## Memorandum

Date: April 5, 2016

From: ICC/ANSI A117 Editorial Task Group

Re: Inconsistency Questions in 2015 A117.1 Draft

## Illustration 2 This illustrates the conflict between Items 2a, 2b and 2d of Editorial Task Group 4/5/16 Inconsistency Questions Memo

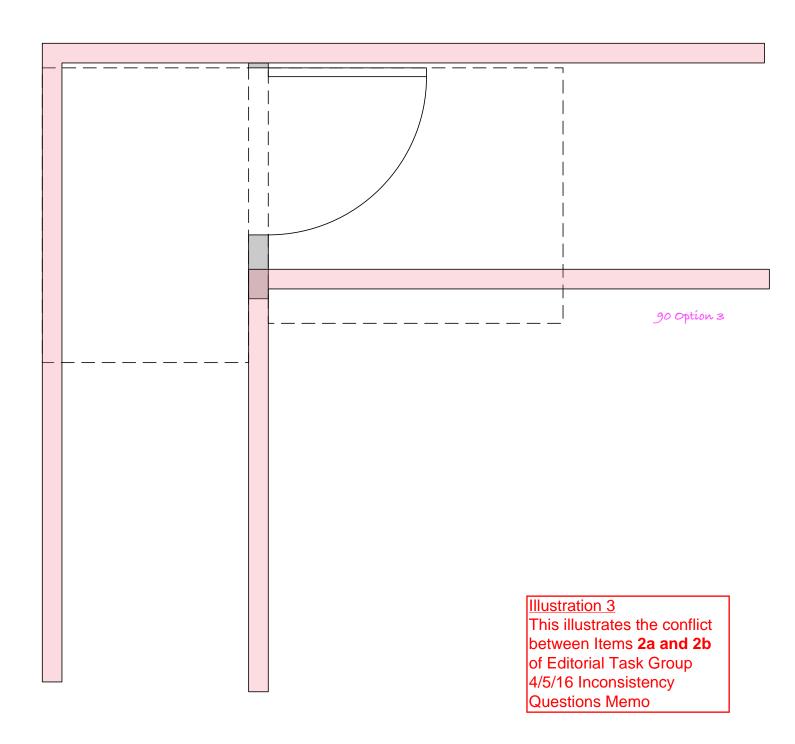
Example of the problem: The 32" narrowing is allowed at doorways along a 36" route. If there is a turn into a door or doorway, the 90 degree turn does not have an allowance for the reduction to 32" until you get past the turn and back to the 36" route. In turns where there is no limit on the depth of the turn (See Illustrations 1 and 2), how far back does the door have to be from the turn? Is it allowed on turns that have a cut back corner?

Illustration 9
This illustrates the conflict
between Items 2a and 3 of
Editorial Task Group 4/5/16
Inconsistency Questions
Memo

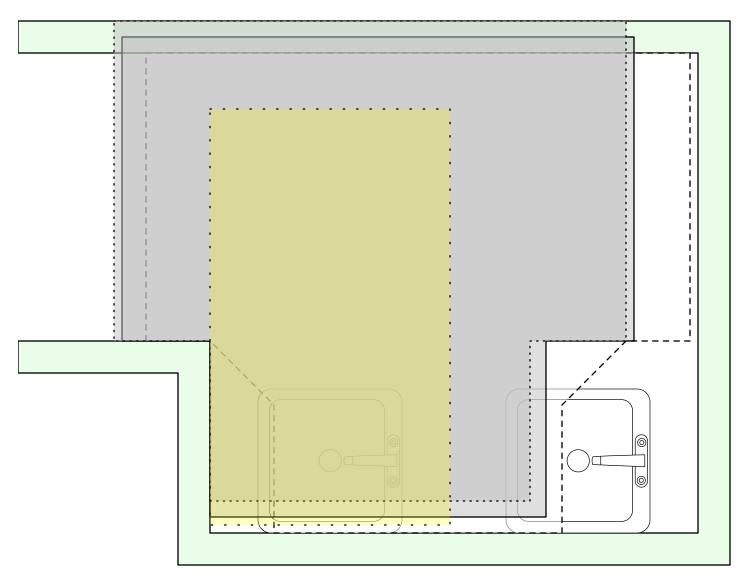
- 3. In addition, the allowance at Section 304.3.2.1 for knee and toe clearance at a turning space is inconsistent with the alcove provisions in Section 305.7. (See Illustrations 6-10) For instance, the text fails to establish whether the chamfered area belongs to an arm or base of the "T" or to both? The result is that we cannot determine how much, if any, of the chamfered area can be overhung by an object permitted to overhang one arm or the base.
